Project	IEEE 802.16 Broadband Wireless Access Working Group http://ieee802.org/16 >
Title	Fixes for Network Entry Flow Charts
Date Submitted	2007-02-15
Source(s)	Nadav Lavi et al Alvarion Ltd. [Address Line 1] [Address Line 2] Voice: +97236457834 Fax: [Fax Number] [mailto:Nadav.lavi@alvarion.com]
Re:	IEEE Std 802.16-2004/Cor2/D1
Abstract	Fixes for Network Entry Flow Charts in 802.16-2004/Cor2/D1
Purpose	For the review in 802.16 Maint TG
Notice	This document has been prepared to assist IEEE 802.16. It is offered as a basis for discussion and is not binding on the contributing individual(s) or organization(s). The material in this document is subject to change in form and content after further study. The contributor(s) reserve(s) the right to add, amend or withdraw material contained herein.
Release	The contributor grants a free, irrevocable license to the IEEE to incorporate material contained in this contribution, and any modifications thereof, in the creation of an IEEE Standards publication; to copyright in the IEEE's name any IEEE Standards publication even though it may include portions of this contribution; and at the IEEE's sole discretion to permit others to reproduce in who

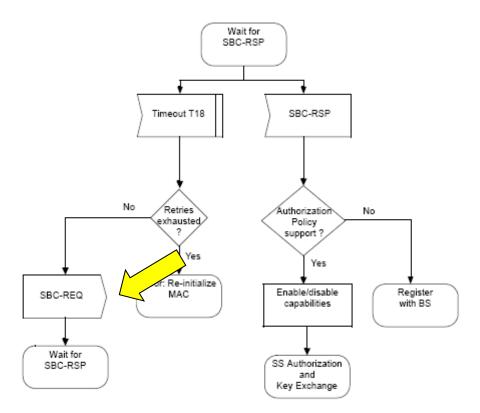
There is an unclear definition of how to handle expiration of T9 in the BS side in SBC transaction, and expiration of T17 in the BS side in REG transaction. The condition for "Release and age-out connections" is unclear and not well defined. In addition, this action is local to the BS and thus remains unknown to the SS. We suggest that the BS would send unsolicited RNG-RSP message with Abort instruction when these timers expire. The current Network Entry flow chart cannot handle retransmission, either due to processing delays or message drop. After the BS transmits a response message, it will proceed directly to the next state in the Network Entry flow and thus cannot handle a retransmission of request by the SS; this would cause the Network Entry procedure to end in failure. For example, the following flow chart (Figure 67 in 802.16e-2005) shows that BS sends SBC-RSP.

If the SS does not receive SBC-RSP within T18 timeout, it will retransmit the SBC-REQ (Figure 66).

Figure 70—Registration—BS

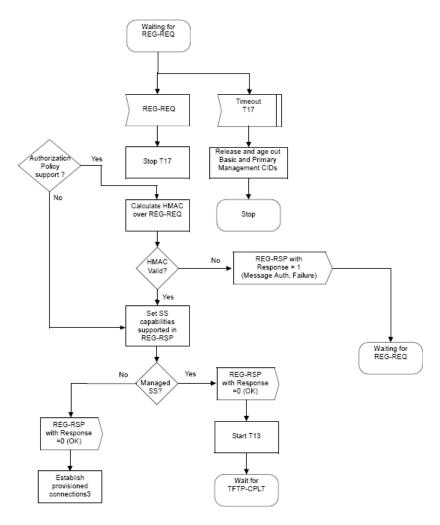
However after sending SBC-RSP, the BS proceeds directly to the registration step. The corresponding flow chart (Figure 70) does not contain any state where a retransmission of SBC-REQ can be received and processed. This is just an example of one single scenario. Similar failures can be identified for other steps in the entire Network Entry flow.

In Cor2_D1, replace in 6.3.9.9 Figure 70 with the following Figure 70a and Figure 70b:

Figure 67a-Handle SBC-REQ first reception, BS side.

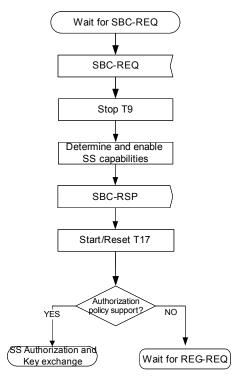
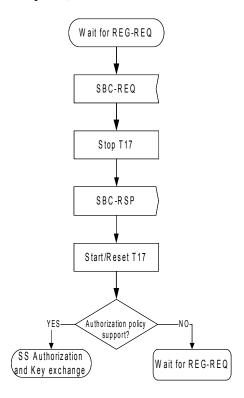
In Cor2_D1, replace Figure 67 in 6.3.9.7 with the following Figure 67a and 67b:

Figure 69 – Handle REG-RSP, SS side.

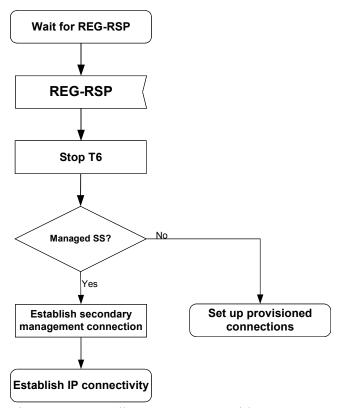
In Cor2 D1, replace Figure 69 in 6.3.9.9 with the following figure:

Figure 66 - Handle SBC-RSP, SS side.

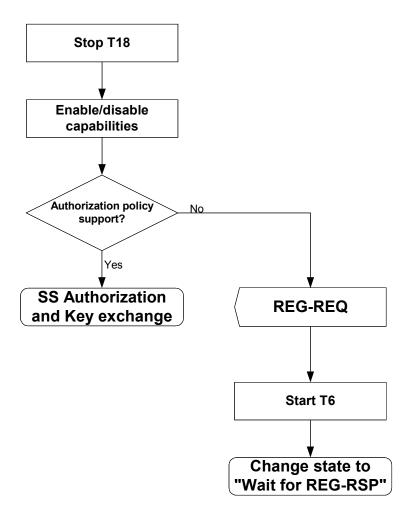
In Cor2_D1, Replace Figure 66 in 6.3.9.7 with the following figure:

Figure 87a - Handle CDMA Initial Ranging Code at BS

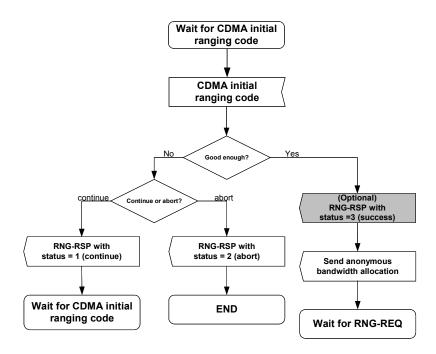
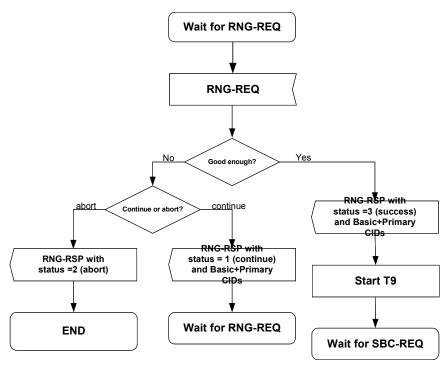
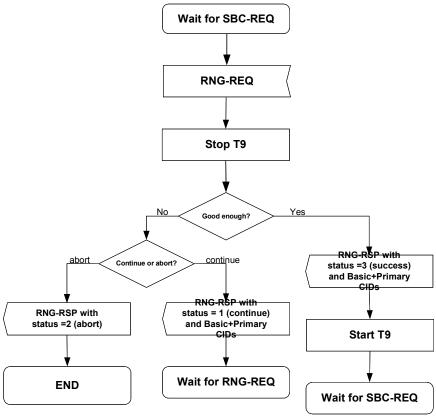
In Cor2_D1, replace Figure 87 with the following Figure 87a, Figure 87b and Figure 87c:

Figure 70c - Network entry state-machine BS side

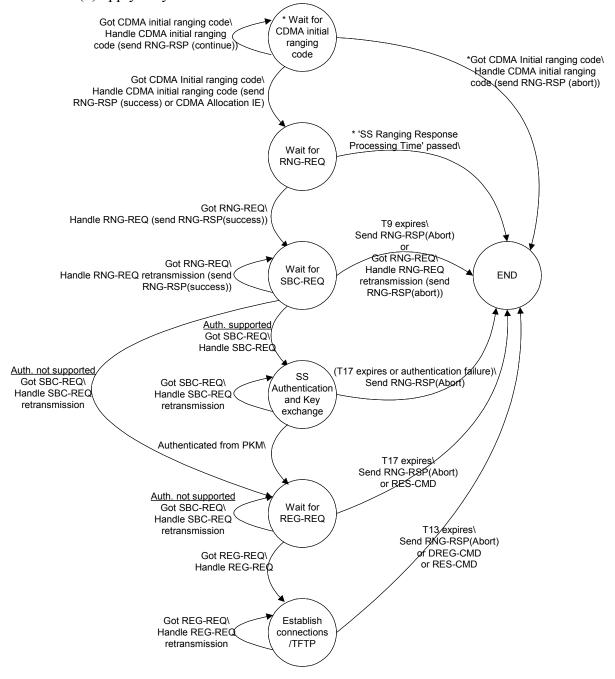
In Cor2_D1, add the following text at the end of Section 6.3.9.9, and change Figure 70a with the following Figure 70c:

The following Figure describes the NW entry process on BS side. The transitions and states that are marked with asterisks (*) apply only to OFDMA PHY.

Figure 70d - Network entry state-machine SS side

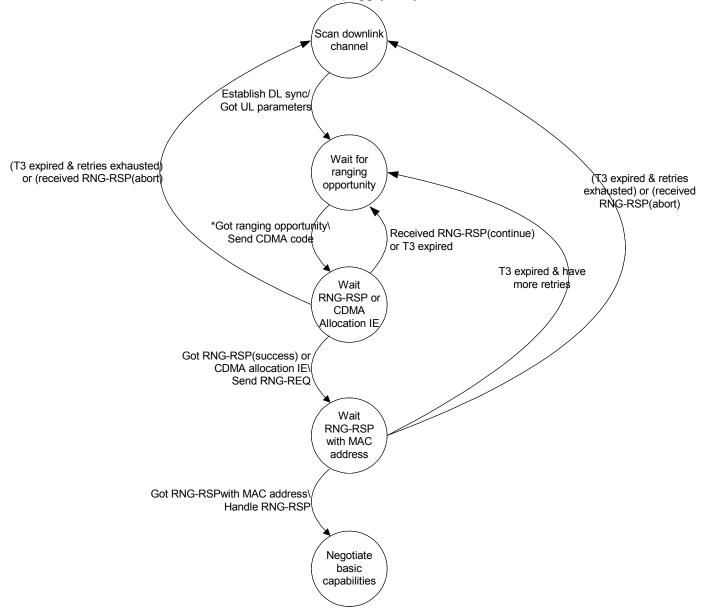
In Cor2_D1, add the following text at the end of Section 6.3.9.9, and change Figure 70b with the following Figures 70d:

The following Figure describes the Ranging procedure within the NW entry process on MS side. The transitions and states that are marked with asterisks (*) apply only to OFDMA PHY.

Figure 70e – Network entry state-machine SS side

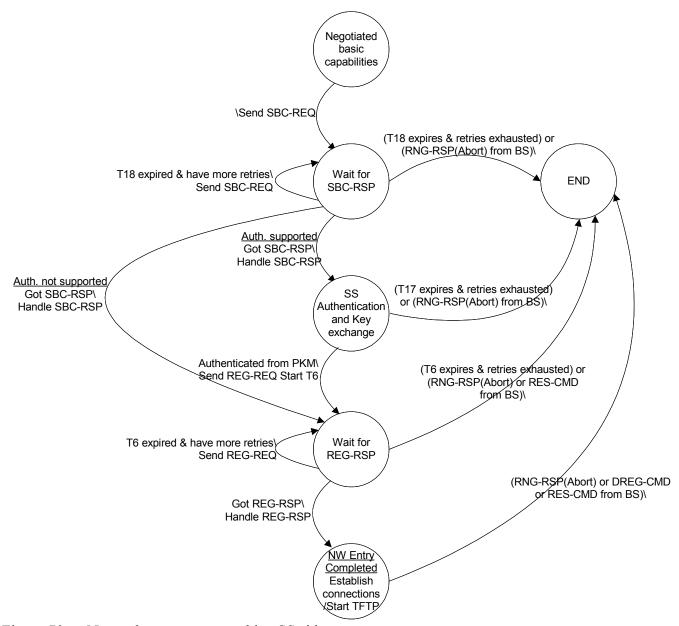
In Cor2_D1, add the following text at the end of Section 6.3.9.9, and add the following Figure 70e: The following Figure describes the Ranging procedure within the NW entry process on MS side. The transitions and states that are marked with asterisks (*) apply only to OFDMA PHY.
